ATTACHMENT 1

Comments

Subject: Draft Environmental Impact Statement (DEIS) for the Tehachapi Upland Multi-Species Habitat Conservation Plan, Kern and Los Angeles Counties, CA (CEQ # 20090011)

Cogan Figure 1 on left; DHCP Figure 4-1 on right.

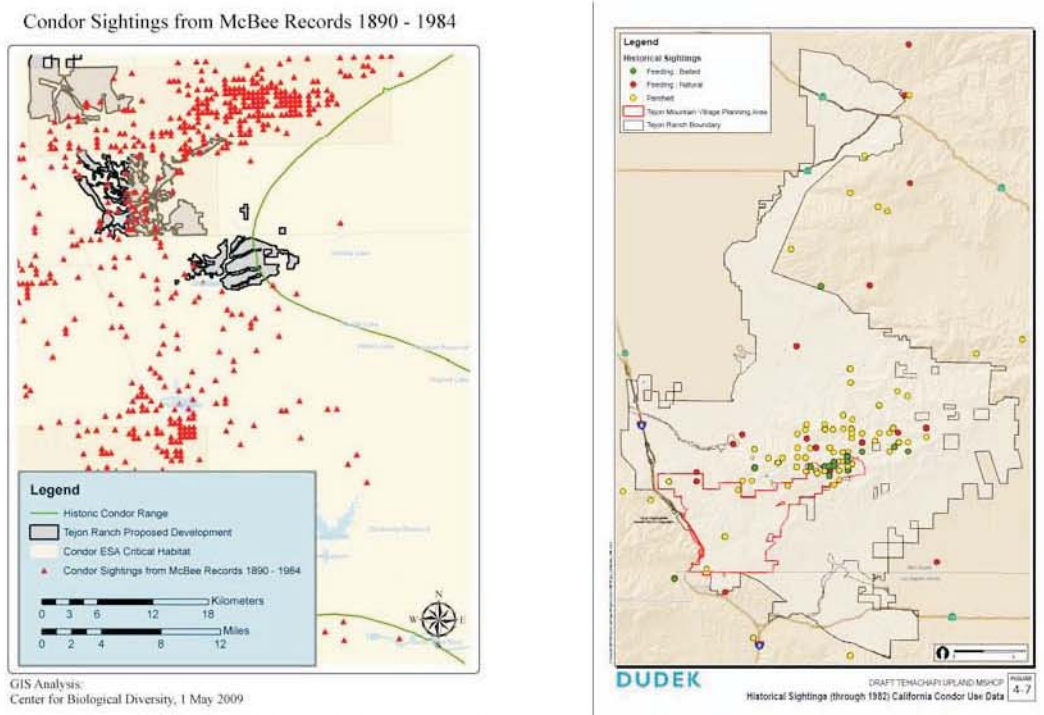
The selective bias of the DHCP and the DEIS is also apparent in the map showing the historic range of the condor (DHCP Figure 4-1, DEIS Figure 3.1-6). Tejon Ranch is represented here as occupying only a small portion of the core, or linchpin, of the “wishbone” of historic condor habitat. Yet this representation of condor habitat is inaccurate: it suggests condor use far into the floor of the San Joaquin Valley. The DHCP itself admits that condors have not, and do not, utilize the valley floor to any significant extent (DHCP pp. 4-9 and 4-66). An accurate portrayal of historic condor habitat, as is found on page 3 of the 1996 Condor Recovery Plan and in Figure 1 of the Cogan report, reveals a far closer relationship between Tejon Ranch and the center of the “Y” of historic habitat:

Rather than the apparently-insignificant relationship represented in the DHCP and the DEIS, the ranch actually spans the entire habitat range – it is the entirety of the core connecting property. And the three development proposals, not shown in Fig. 4-1, substantially block the entire span of habitat (Cogan 2009, Figure 1).

Figure 1. Locator.

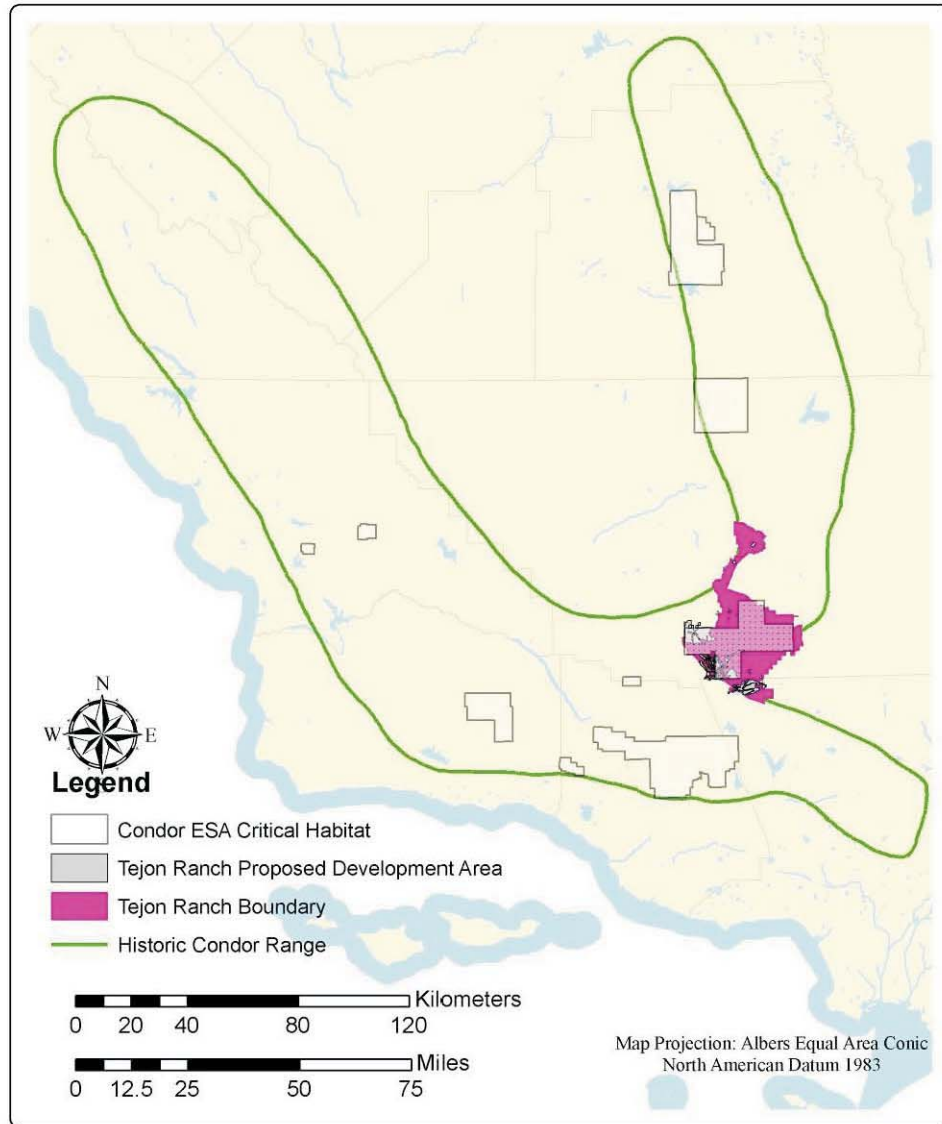
Figure 1. Locator Map. Historic California condor range, ESA designated critical habitat zones, Tejon Ranch property, and proposed Tejon Ranch development area.

Figure 2. WWF.

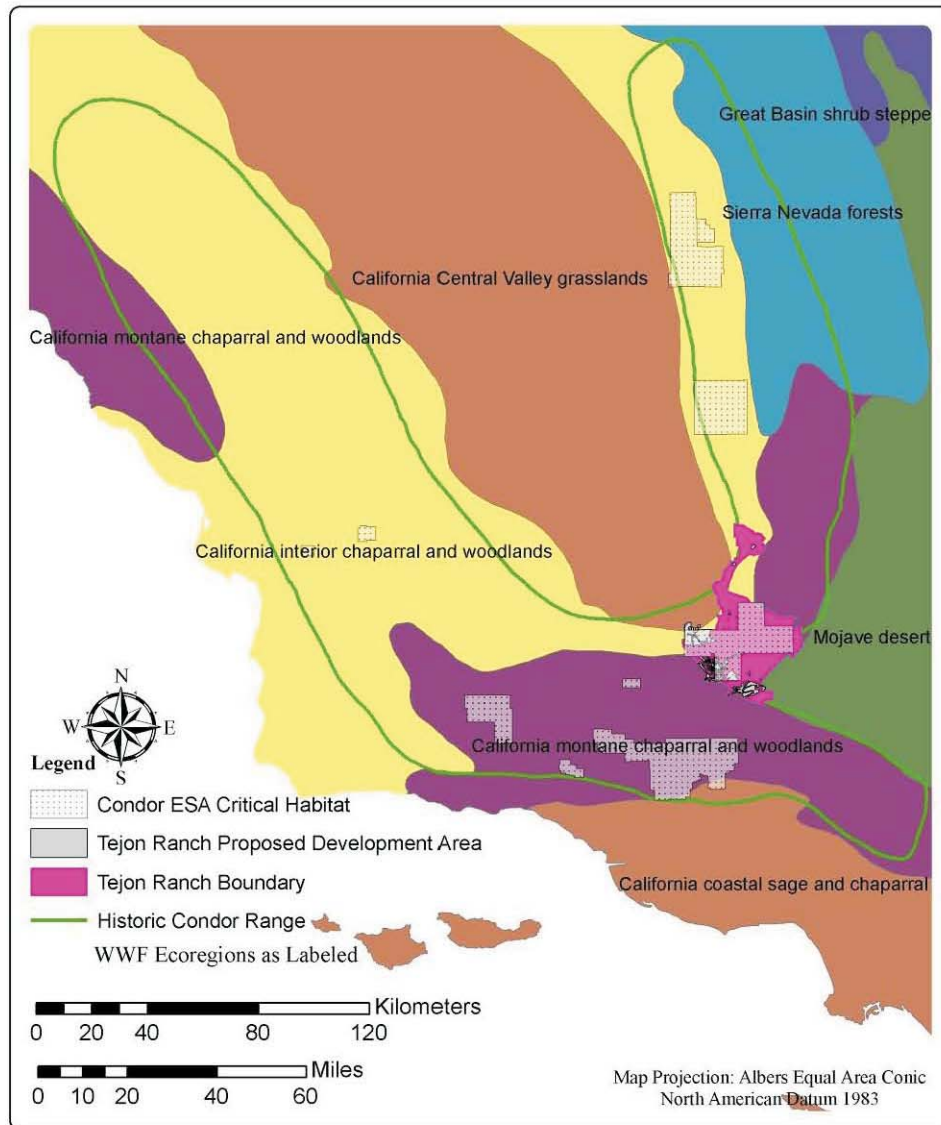
Figure 2. WWF Ecoregions. The original condor range map from Figure 1 was drafted as a general consensus by condor researchers. Figure 2 brings in an independent data set, the World Wildlife Fund for Nature terrestrial ecoregions (see also Hickman 1993, for the Jepson ecoregion version). Condors tend (with some exceptions) to avoid the California Central Valley and the Mojave Desert. This map provides further explanation for the constriction of the condor range in the Tejon Area, and highlights the uniqueness and importance of the region.

Another habitat property illustrated in Figure 2 is the division of the Tejon Ranch Proposed Development area into four major ecoregions, in particular the California interior chaparral and woodlands vs. the California montane chaparral and woodland types (yellow and purple in the map). Following general ecological principles, any consideration of habitat impacts or endangered species impact needs to treat each ecoregion separately. This is particularly important when considering how condors use habitats in multiple ecoregions and how a species such as the condor can act as an umbrella species.

Figure 4. Visual.

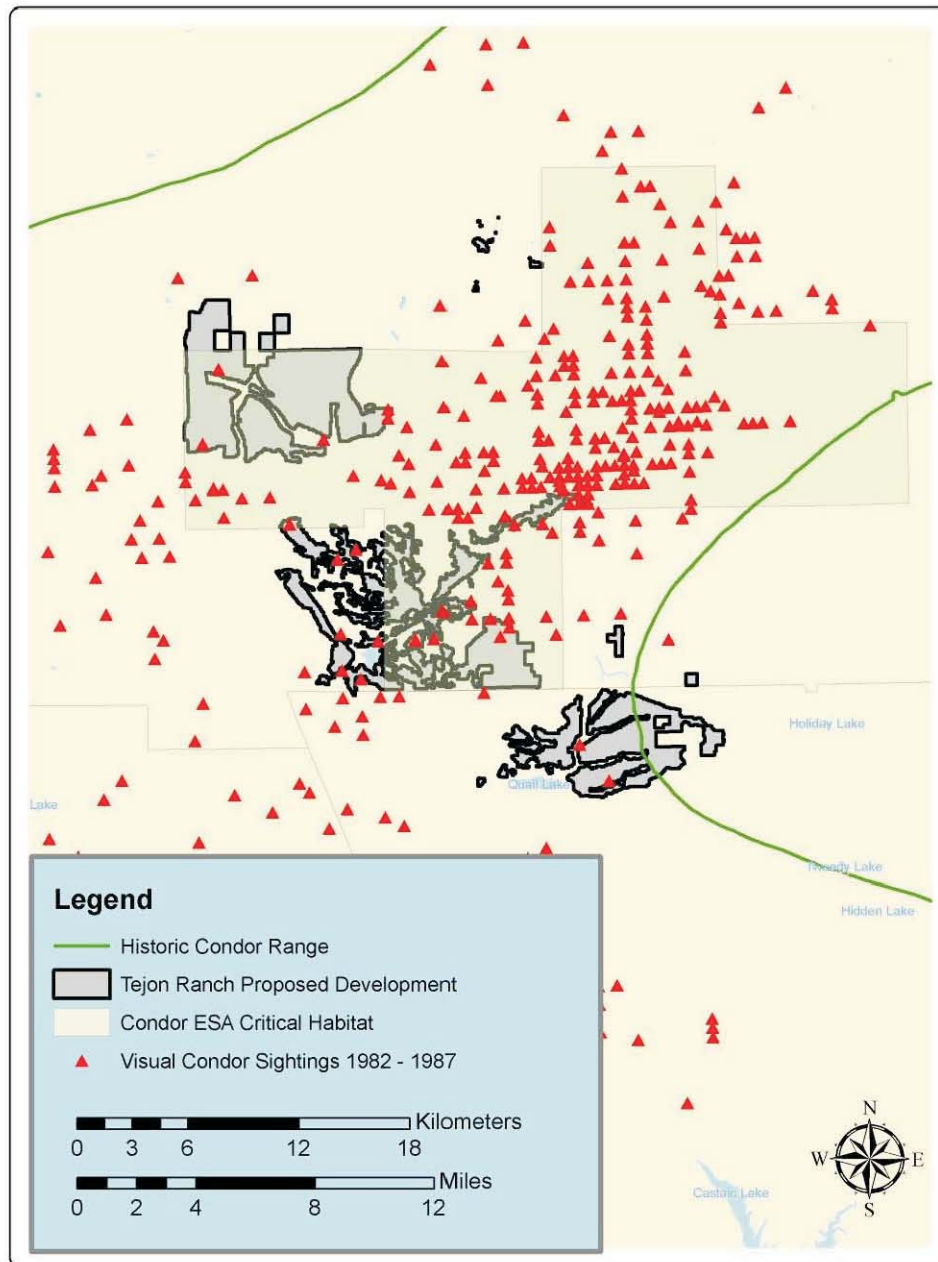
Figure 4. Visual Records. The visual sighting data represented in Figure 4 are based on data collected by field researchers. From 1982 through 1987 there were 10,294 records collected, with approximately 1,800 in the Tejon Ranch area. Corresponding condor ID's (CID) include 11 individuals (0, 1, 2, 3, 4, 5, 6, 7, 8, 9, and 97). CID code 97 indicates "unknown adult condor". Note how the spatial patterns of habitat use are consistent with the earlier McBee records.

Figure 5. Flight lines.

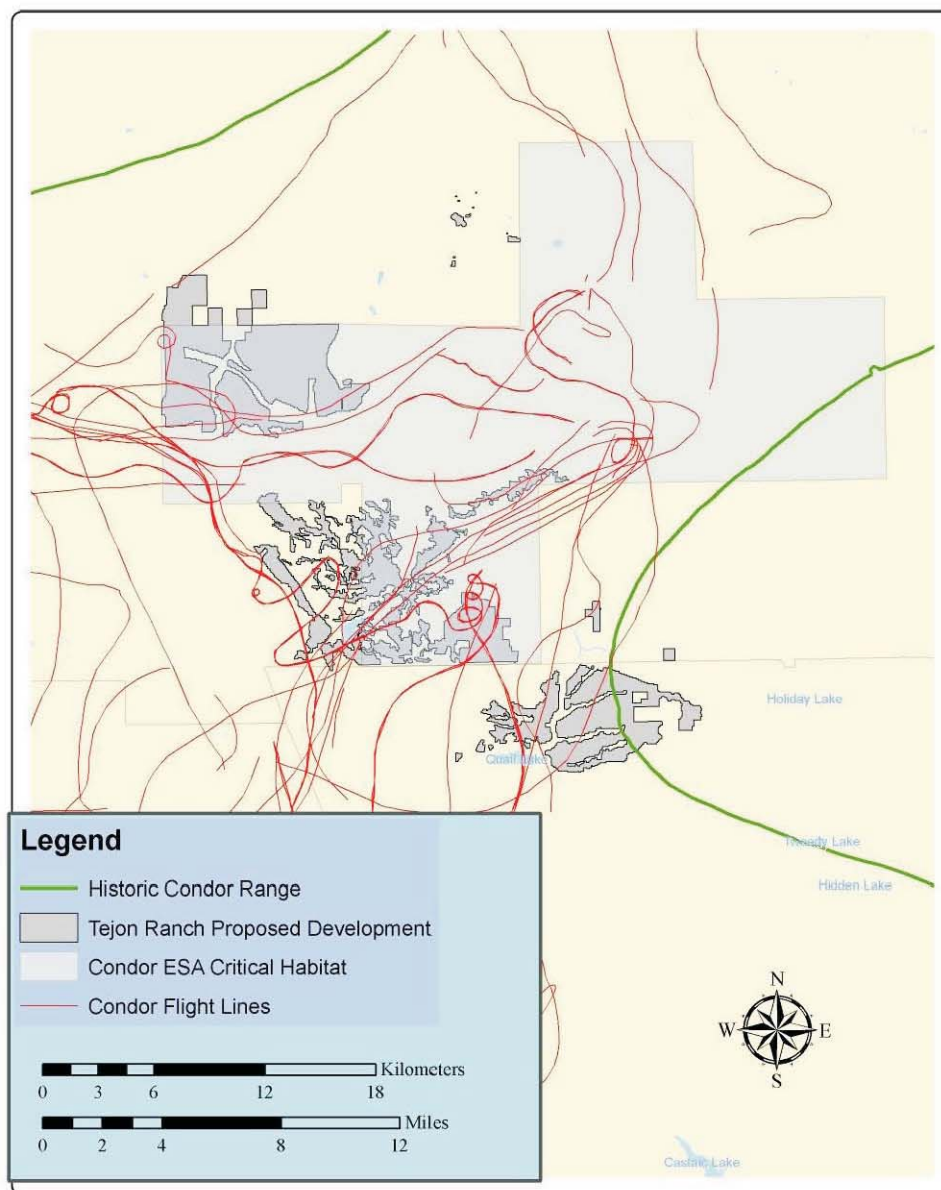
Figure 5. Flight Lines. From the period 1982 – 1986 condor biologists in light aircraft used radio telemetry to locate tagged condors, then observe the birds visually and follow them in flight. While flying, the pilots drafted their course on county-scale maps, which were later digitized and compiled in GIS format. The flight data are unique, because they provide a consistent visual record of bird movements over large areas for a five-year period. Though the wild population was very small in these years, the Tejon area data include records from six individual birds (condor ID's 1, 2, 5, 6, 8, and 9). Please note that these data are intended as a general indication of flight routes, not as spatially precise as other data types such as the GPS data. In spite of the spatially coarse nature of the maps, the flight data add yet another important form of evidence identifying Tejon Ranch as critical condor habitat.

Figure 6. GPS.

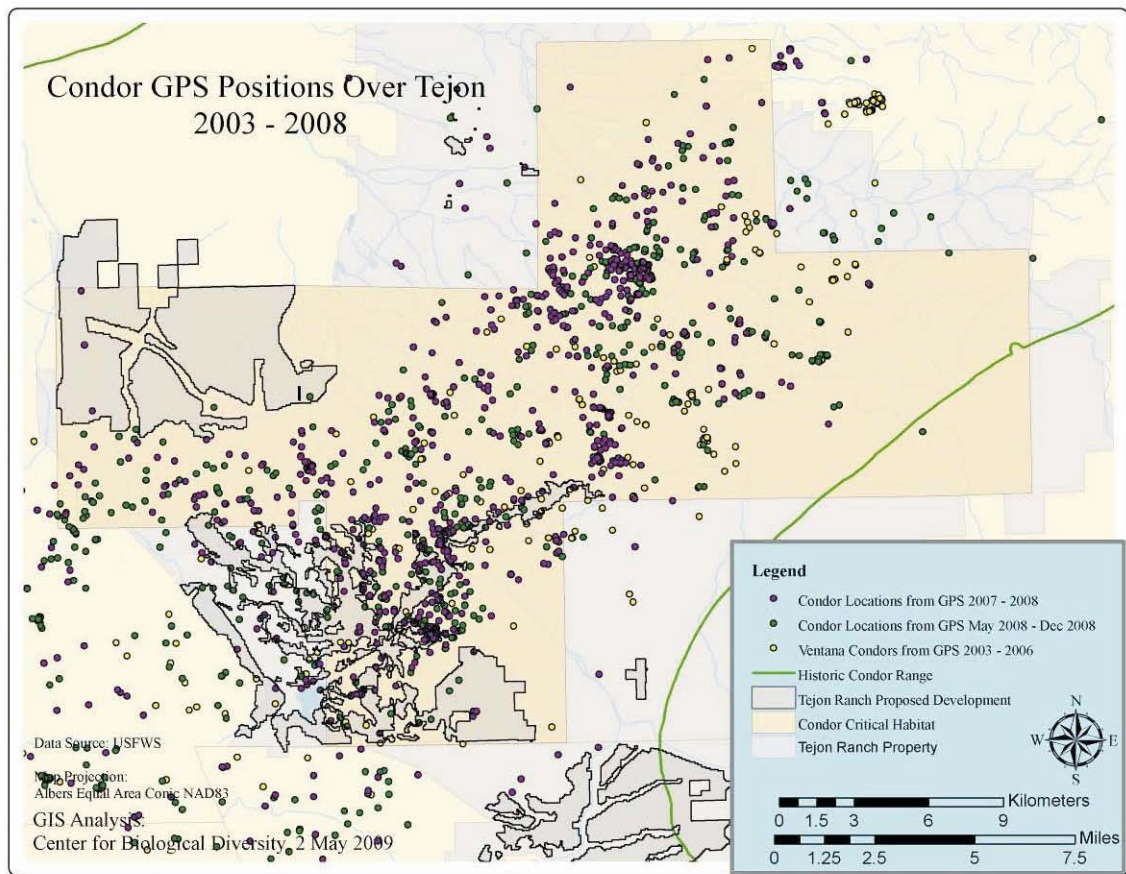
Figure 6. GPS Records. The GPS satellite telemetry data on condor locations represents a true breakthrough in data collection technology. The massive data volumes and quality of data offer critical insights to condor habitat use. The GPS locations plotted in figure 6 are from three USFWS data sets:

Of particular note with all of the Figure 6 records is the spatial correlation of the high accuracy GPS data with the older visual data sets, including the flight line data.

Figure 7. Pastoria Creek.

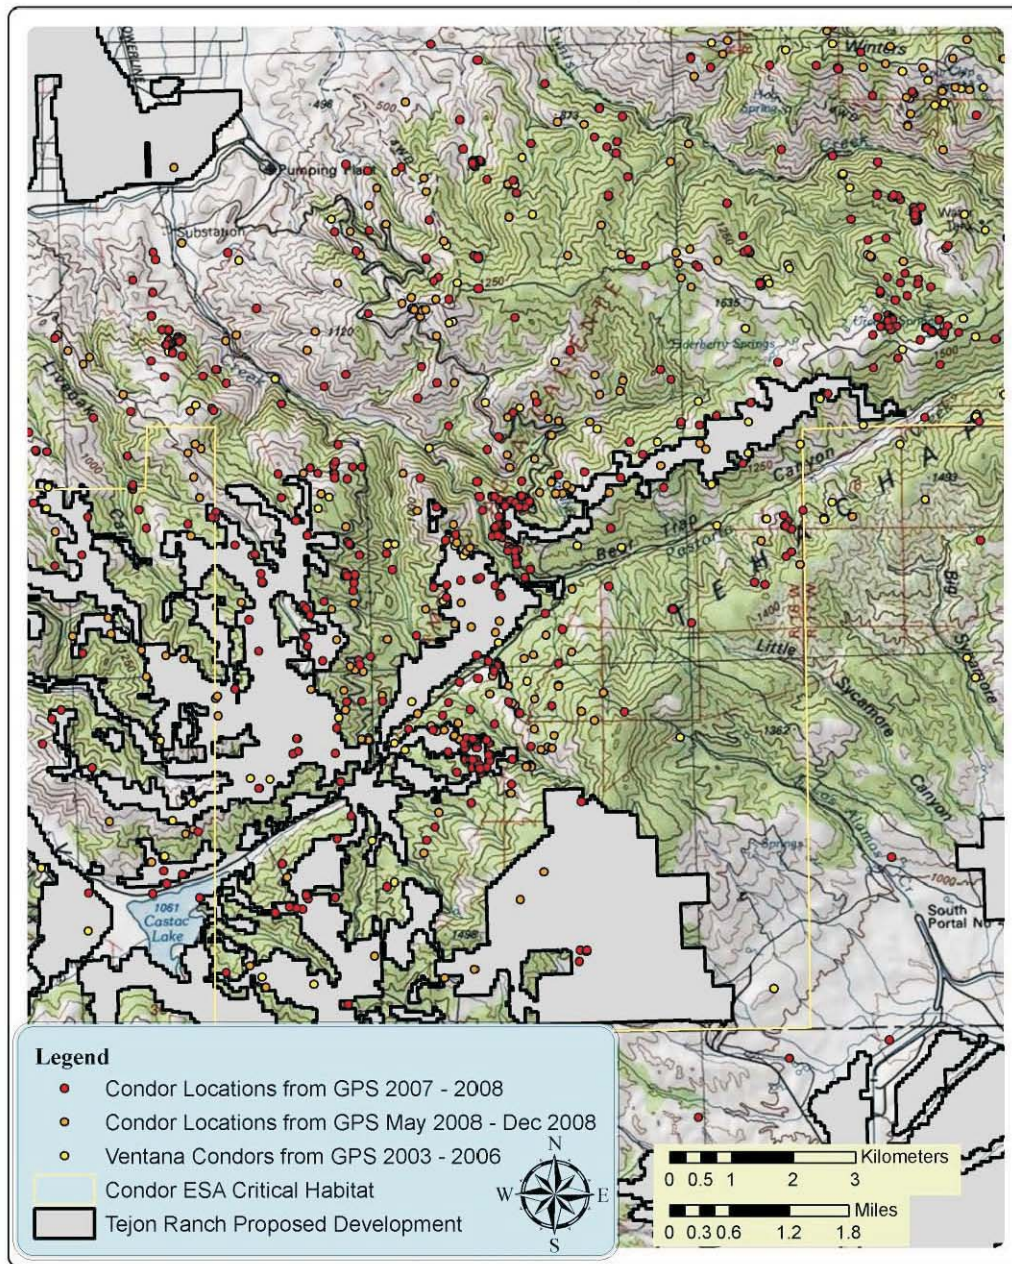
Figure 7. Pastoria Creek Map. Figure 7 is an enlargement of Figure 6, providing detail for key condor activity areas along Bear Trap Canyon and Pastoria Creek within the Tejon Ranch, and specifically within the proposed "Tejon Mountain Village" development area.

Figure 8. Perched.

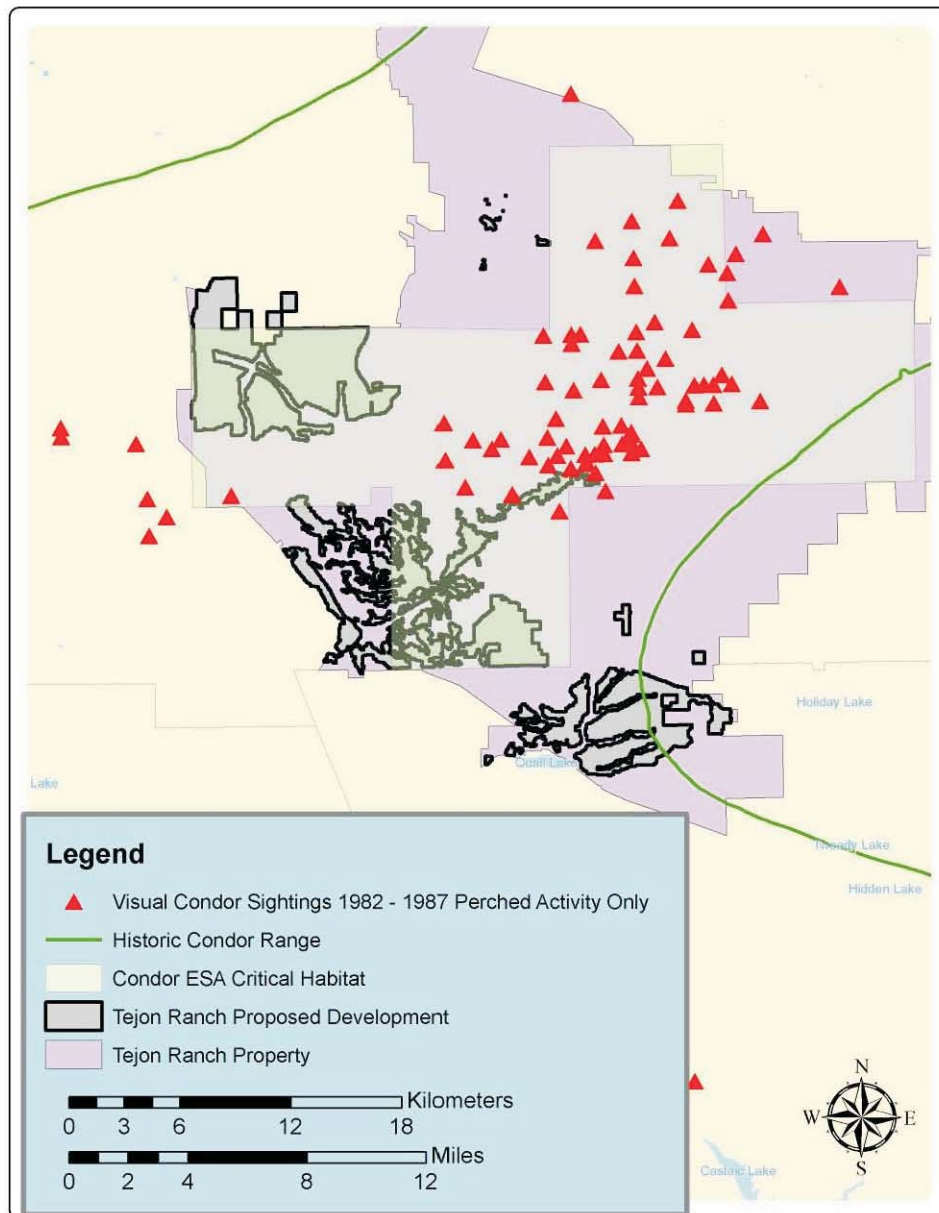
Figure 8. Perched Activity. To determine different types of condor activity within the Tejon Ranch area, the 1982 – 1987 visual data (10,294 records) were reduced to show perched activity only (2,901 records). These data included approximately 600 records in the Tejon Ranch area. Many of the perched records occur in the upland areas above Bear Trap and Tunis Creeks, and in the Winters Ridge area.

Figure 9. Feeding.

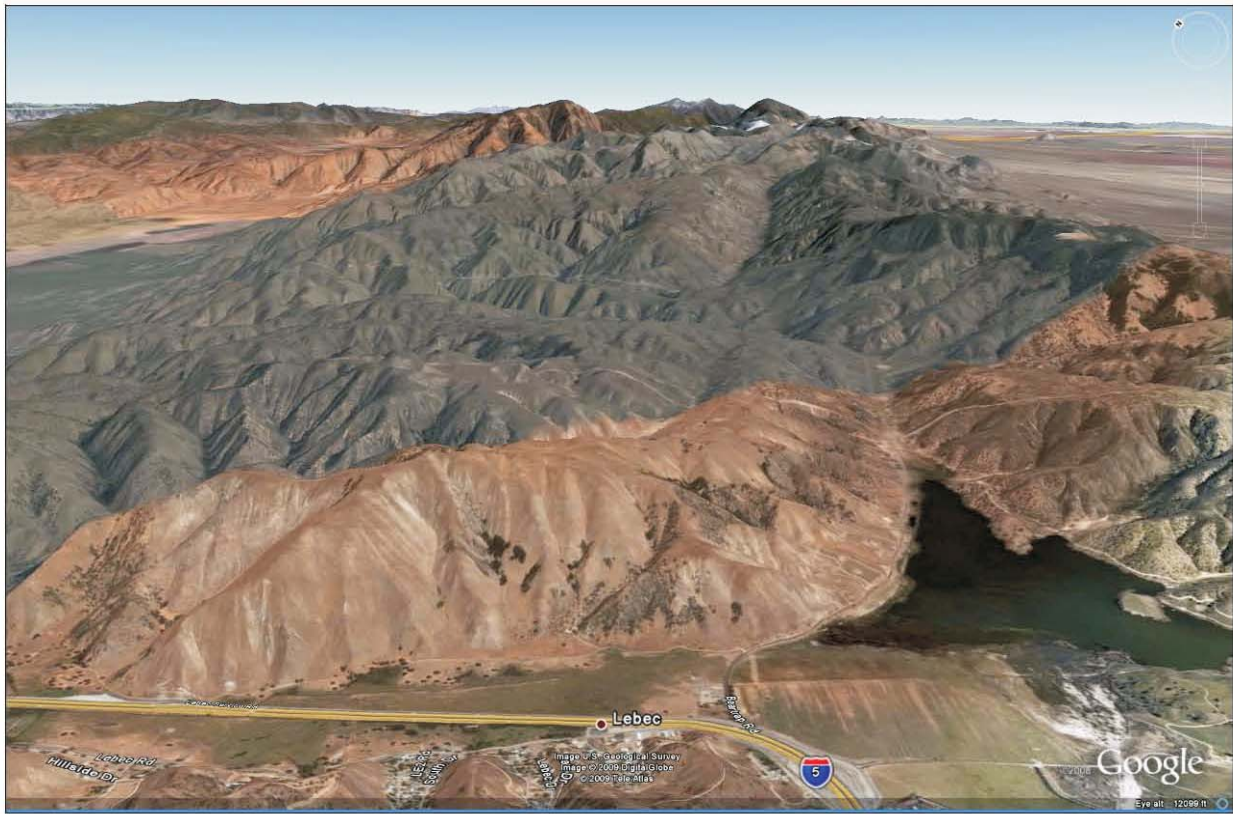
Figure 9. Feeding Activity. Of the 1982 – 1987 visual data records, 777 were coded as feeding records. This figure includes approximately 200 records of feeding condors within Tejon Ranch. Note how most of the feeding locations are well apart from the 5 kilometer buffers around nest locations. Also note how the flight lines that pass over the proposed development areas identify critical habitat which acts to connect the feeding areas with nesting areas. Based on the ecoregion patterns in Figure 2, this figure highlights multiple activities (nesting, flying, and feeding) within the California montane chaparral and woodland ecoregion. This figure also suggests how impacts in the Tejon area could also impact (for example) nesting areas 40 km to the south.
